Bureau of Alcohol, Tobacco,
Firearms and Explosives

Firearms Technology Industry Services Branch

907010:MCP
3311/304296

This refers to your correspondence to the Bureau of Alcohol, Tobacco, Firearms and Explosives (ATF), Firearms Technology Industry Services Branch (FTISB), which accompanied your submitted sample of an "Adjustable Pistol Stabilizing Brace" mounted on a semiautomatic pistol. Specifically, you asked whether the subject device could be lawfully installed on a handgun.

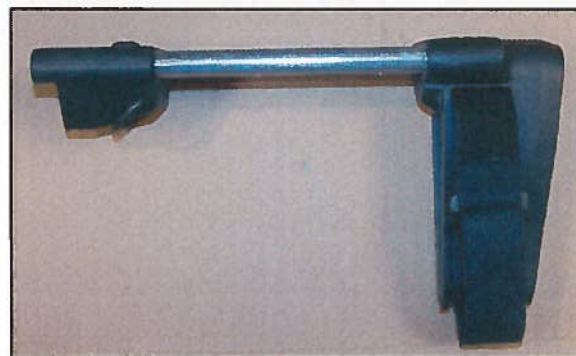
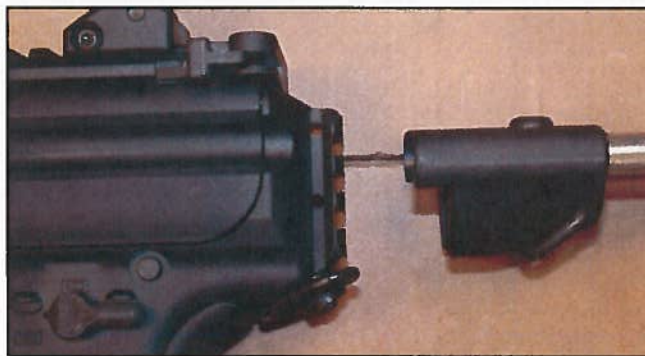
The submitted device (pictured below) utilizes two telescoping metal rods that affix to both sides of an adapter mounted to the rear of a Sig Sauer, Model SIG MPX, 9mm Luger caliber pistol:

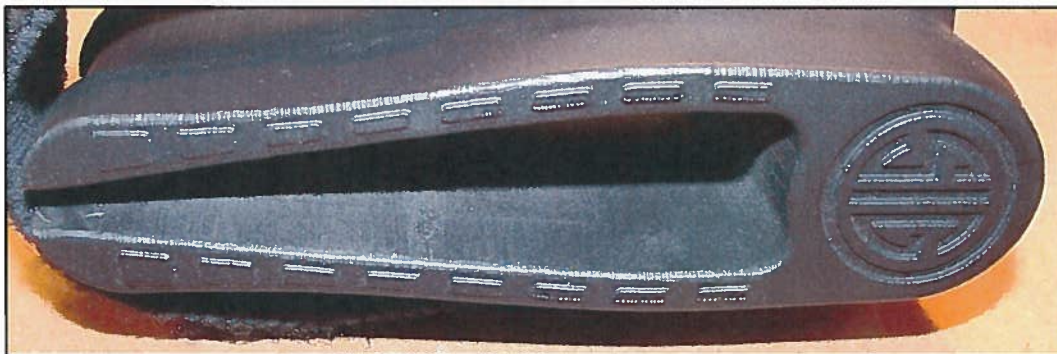
Further, the submitted brace contains a series of raised ridges at its rear (see photo below):

The subject ridges on the rear of the submitted sample serve no functional purpose in the design of a pistol brace; however, the ridges do provide a non-slip, gripping surface, a feature commonly associated with butt stocks/shoulder stocks as well as firearms designed and intended to be fired from the shoulder. You indicate production models will not have this raised surface so as to preclude its usefulness to be shouldered.

Your submission would therefore be approved for use on handguns similar to that attached to your submission, provided there are no raised ridges on the rear of the brace. Its use on smaller, or more conventional handguns, would not be authorized because the purported intent and design offers no benefit for small handguns.

In closing, FTISB finds that the submitted sample is approved for use as a pistol stabilizing brace provided the raised ridges are removed from the rear of the device and not added at a later time.
